# ASHBY USA, LLC

Ref: WPN: 10-3020657.02, 18-2001091.02:schwk  
NOV No. R9-2006-0135

Subject: Required Technical Report

Ashby USA  
Notice of Violation Response  
Photos  
November 28, 2006

Long Valley Wash with berm removed

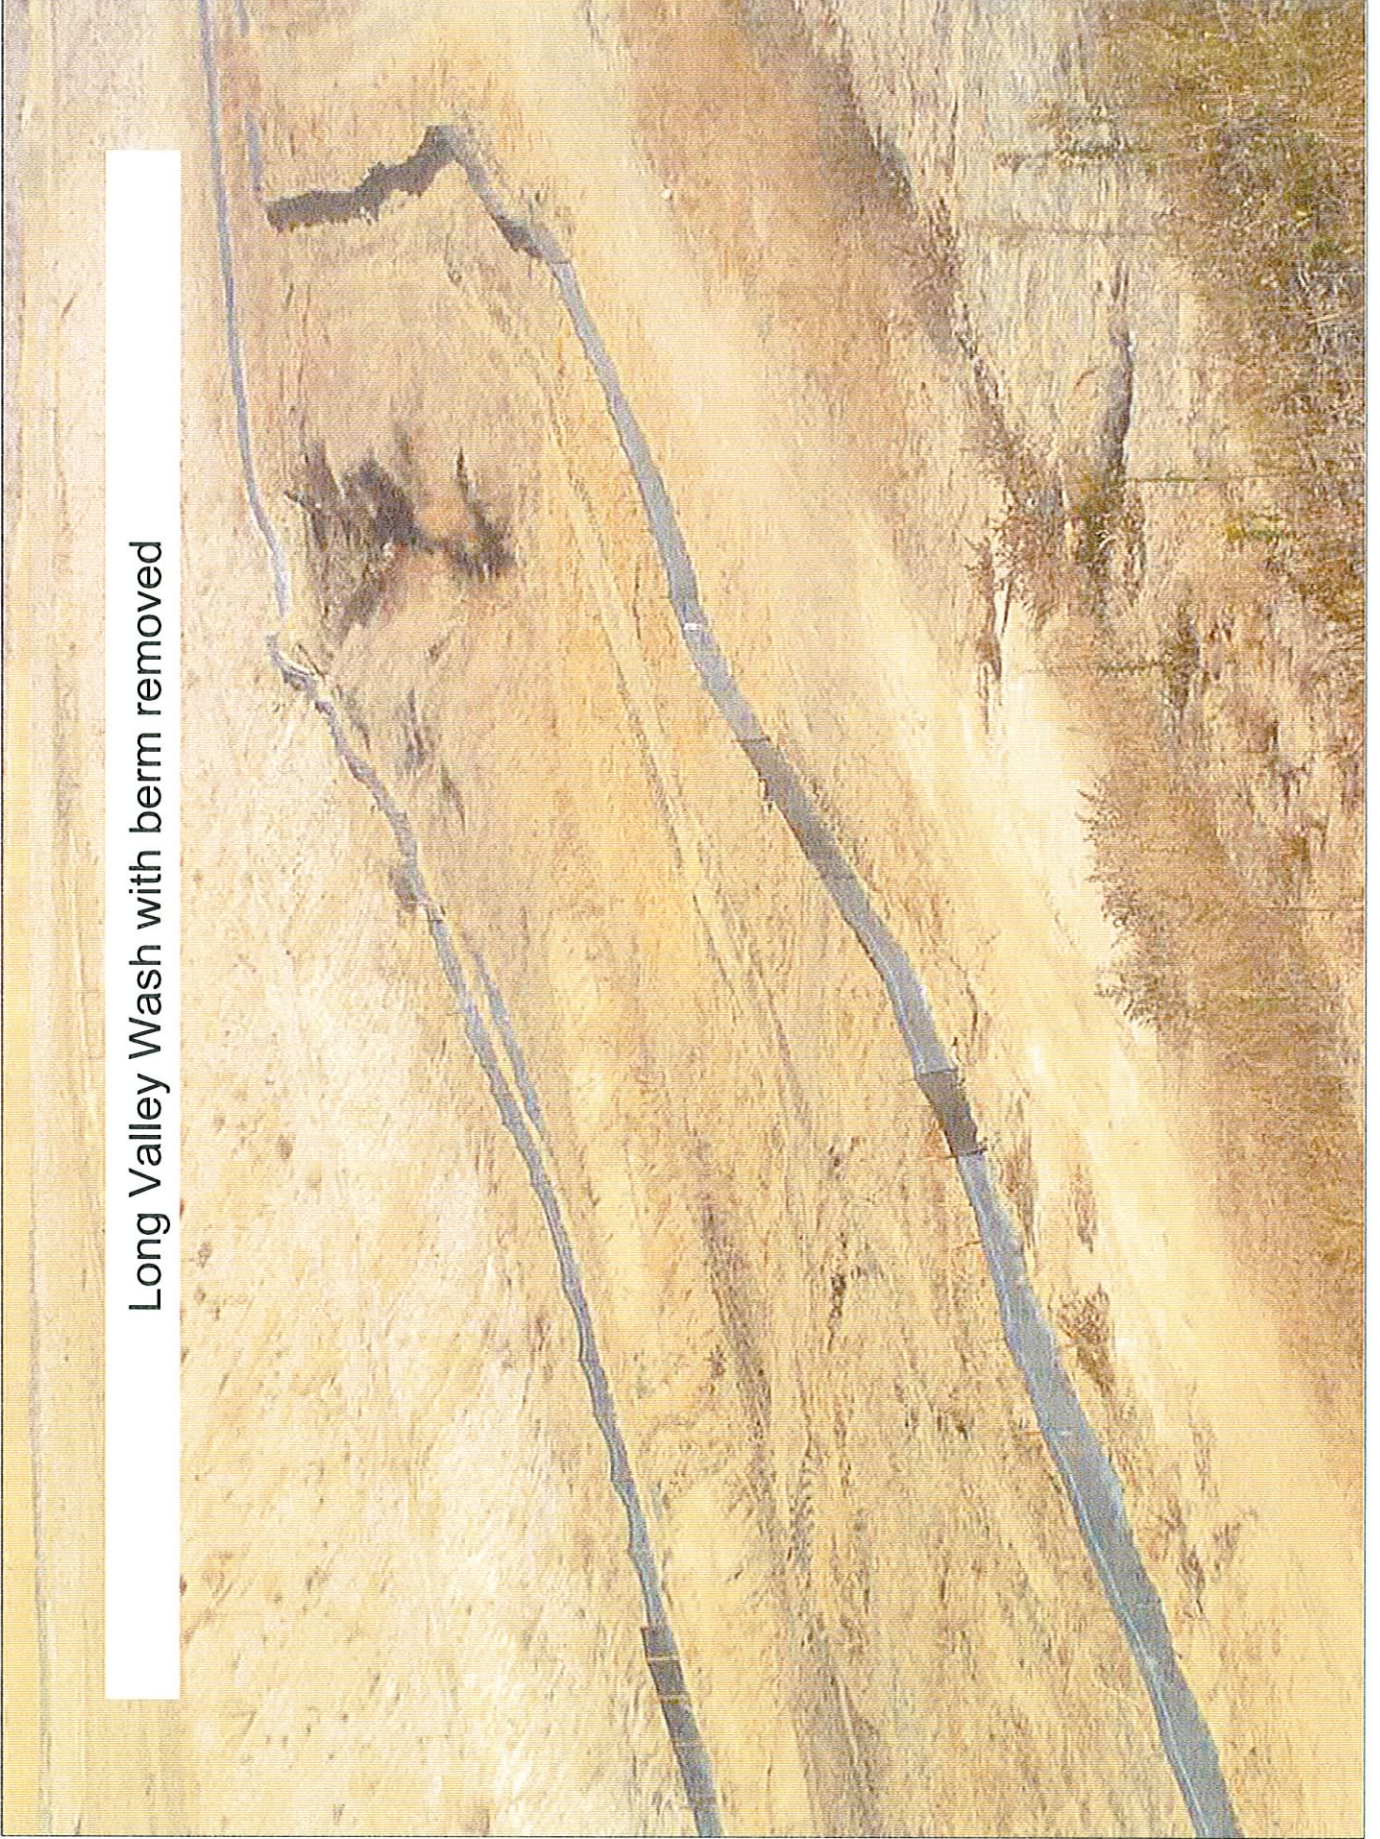
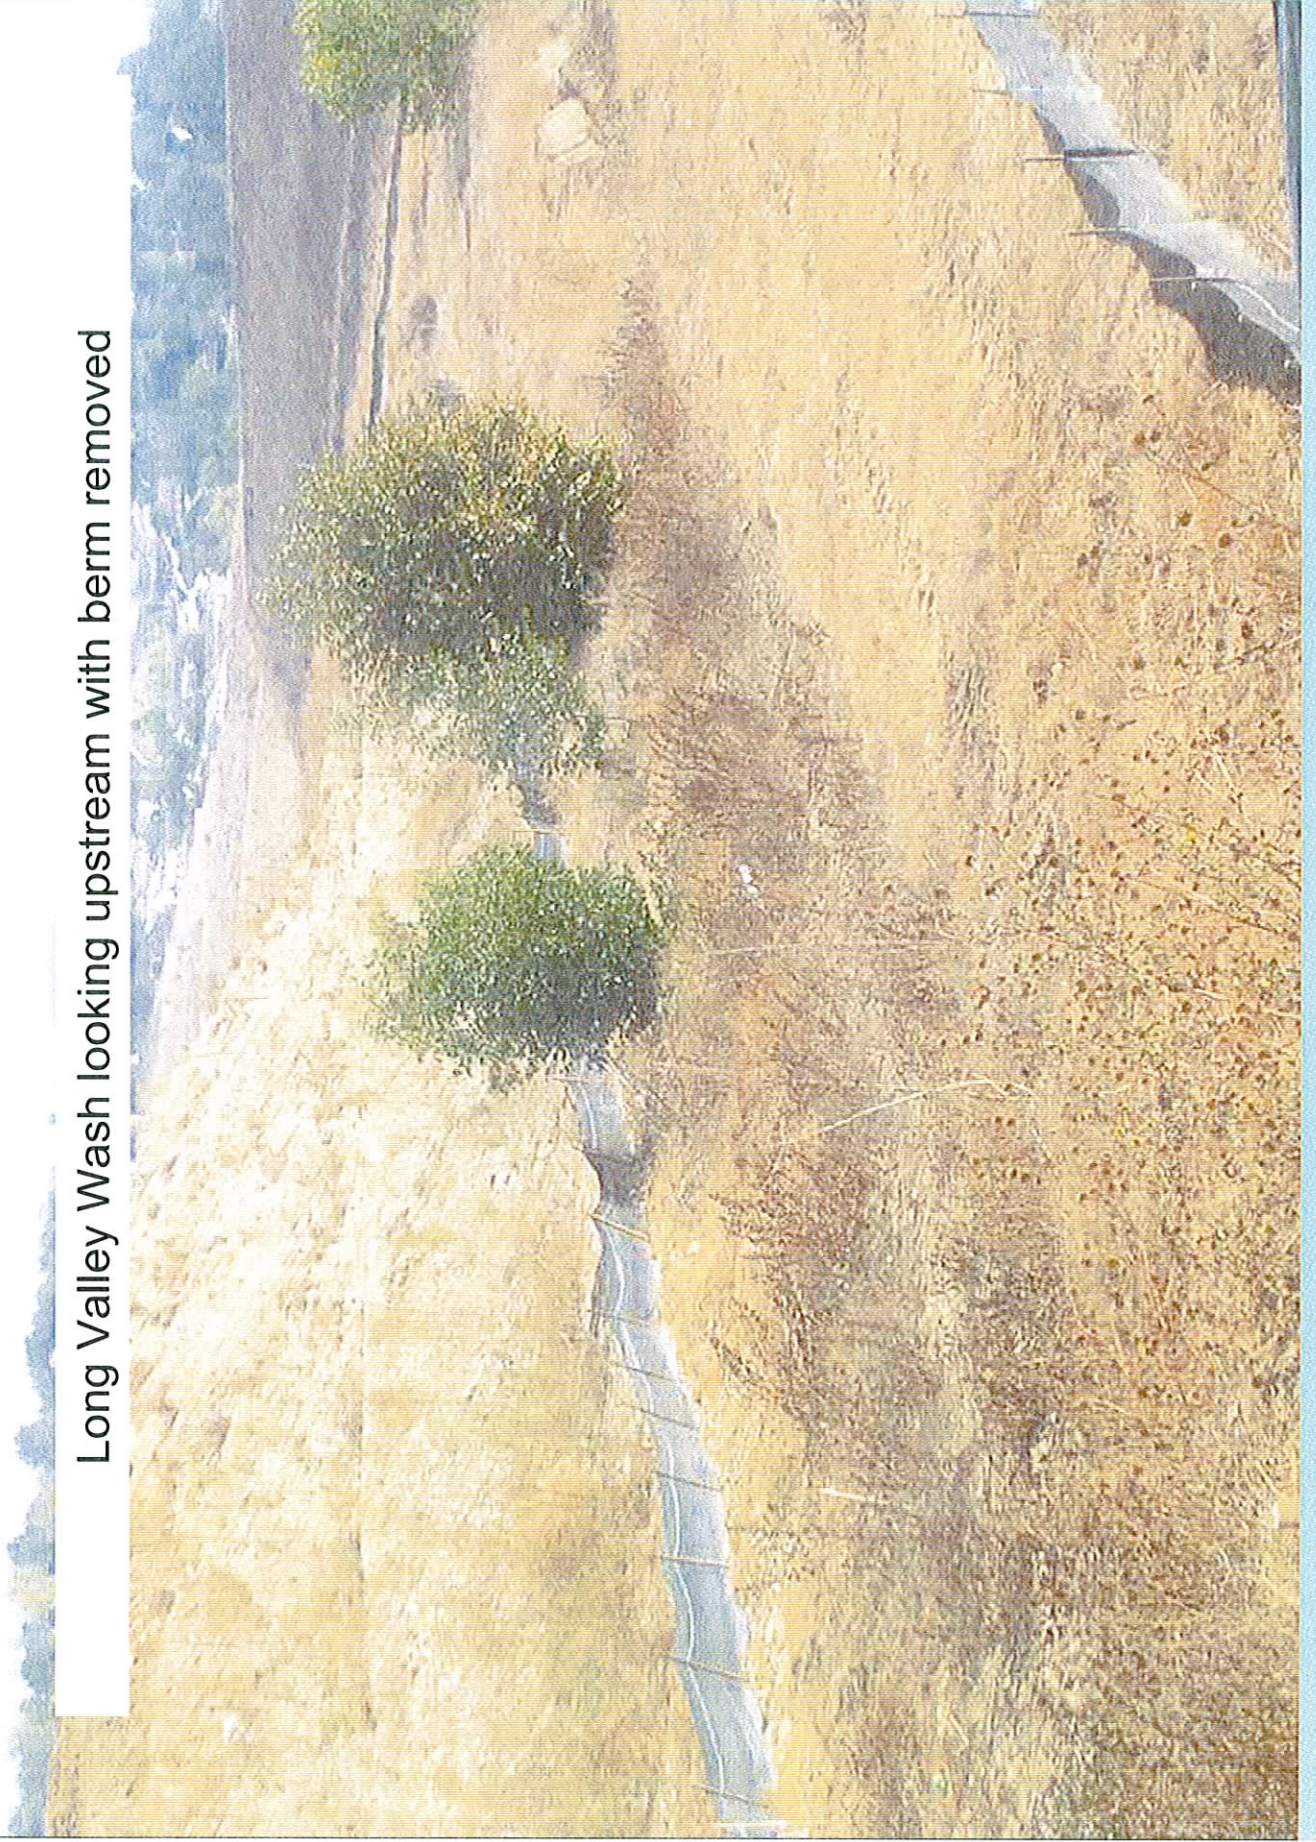
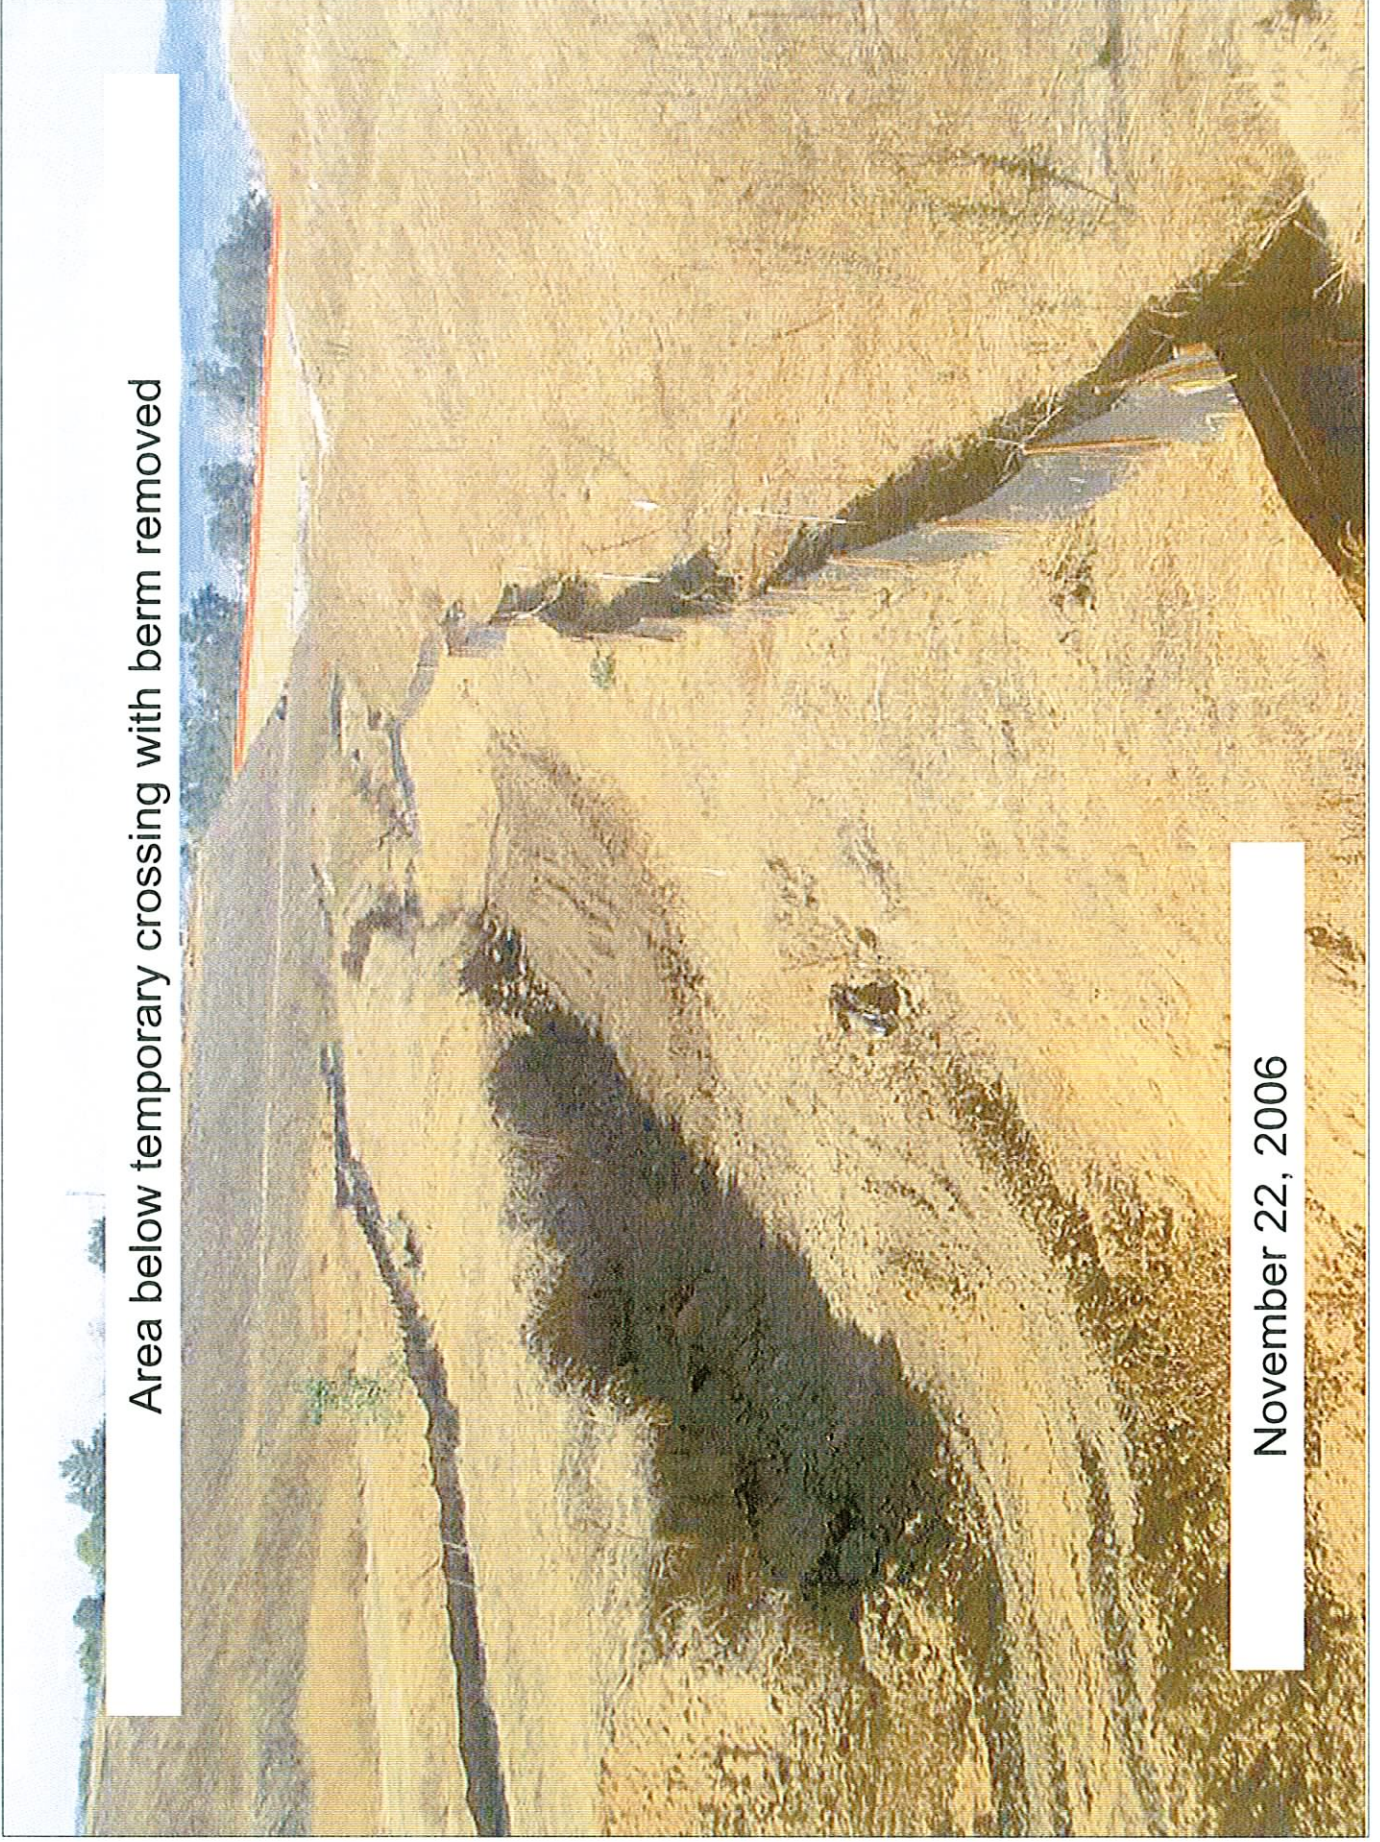
Your site was documented as having disturbed Long Valley Channel Wash from its natural conditions.

Any disturbance to the low flow wash was completed at the direction of the City of Temecula or as approved by the permit and permit modifications. As a result of the site meeting on Wednesday November 15, 2006 with the City of Temecula and CRWQCD, all such disturbances that were not specifically approved by the permit are in the process of being removed and returned to their natural condition and be completed by November 30, 2006 as show on exhibit "A" and sediment traps will only be placed within the permitted areas of impact at the bridge crossings to prevent any sediment discharge from the site.
